**SERVICE BULLETIN NO. 20140717**

**SUBJECT**                      **Missing GPS Information**

**PRODUCT FAMILY**        **WatchDog Sprayer Station and Console**

**AFFECTED UNITS**        WatchDog Sprayer Station with Replaceable Humidity Sensor and Console, item number 3349SSCH, consisting of items 3349SSC and 3349CN, sold between January 1, 2013 and Jul 16, 2014.

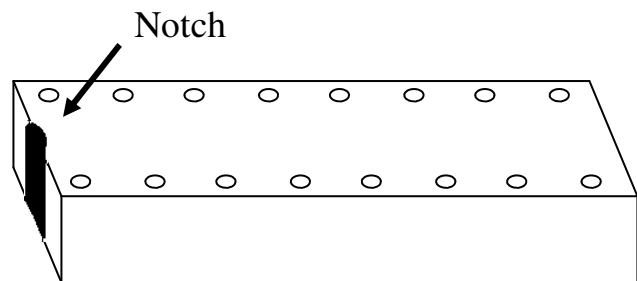
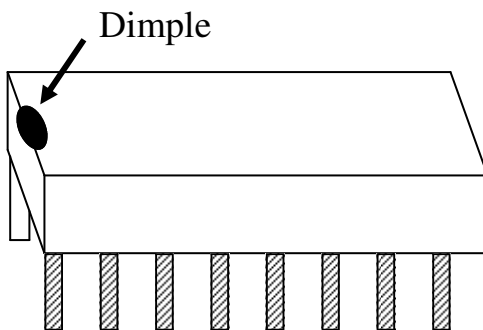
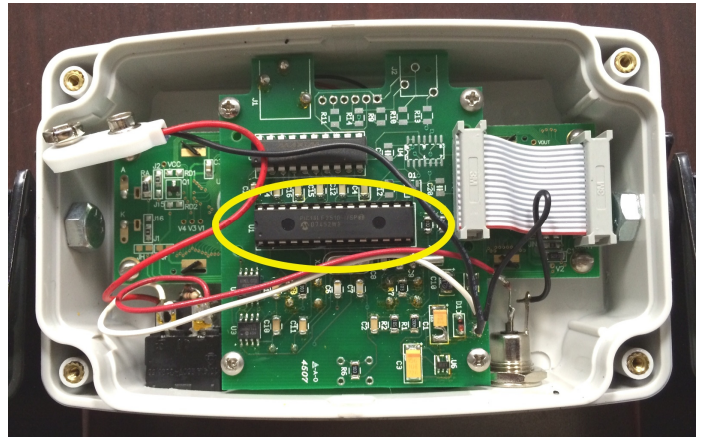
**Concern:** Due to a firmware change by the manufacturer of the GPS module component in the Sprayer Station, UTC may be reported with fractional seconds (hhmmss.ff) instead of integer seconds (hhmmss). The Sprayer Station Console, item 3349CN, was not designed to handle the fractional second format. As a result, true wind speed and direction is not reported when the vehicle is in motion.

1. Remove the Phillips-head screws from the rear cover of the console display, and lift off the cover.
2. Remove the 9 volt battery from its connector.
3. The microcontroller is located in the center. With a small screwdriver, carefully lift the chip out of the socket.
4. Identify the side of the chip with the small dimple. This should align with the side of the socket that has the notch.

The firmware in the Sprayer Station Console has been updated to version 1.4 to handle both UTC formats.

Spectrum Technologies will provide a replacement microcontroller to repair any affected units. Please contact Spectrum to obtain the microcontroller.

5. Carefully line up the pins and the socket and press the microcontroller until it snaps into the socket.
6. Re-insert the battery and re-attach the rear cover.
